# Access Compliance Report

## Public Rights-of-Way

### (Pedestrian Signals)

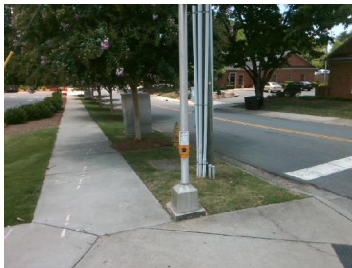
Intersection ID: N/A	Main Street:	Cross Street: N/A	Location: N/A
ADA ID: 44C411F51A1D	Signal Type: One Push Button-APS	Overall Compliance: No	Severity Score: BTN 1: N/A BTN 2: N/A No BTN: N/A
Codes/Mitigation Info/Possible Solution		Field Measurements/Component Compliance

PROW/ADA: R410.6, TMUTCD 4e.08, R404.2, R404.3, R406.2, R209.1, MUTCD 4e.10

Possible Solutions: Replace Signal Push Button With APS Button on New Post. Remove & Replace Sign.
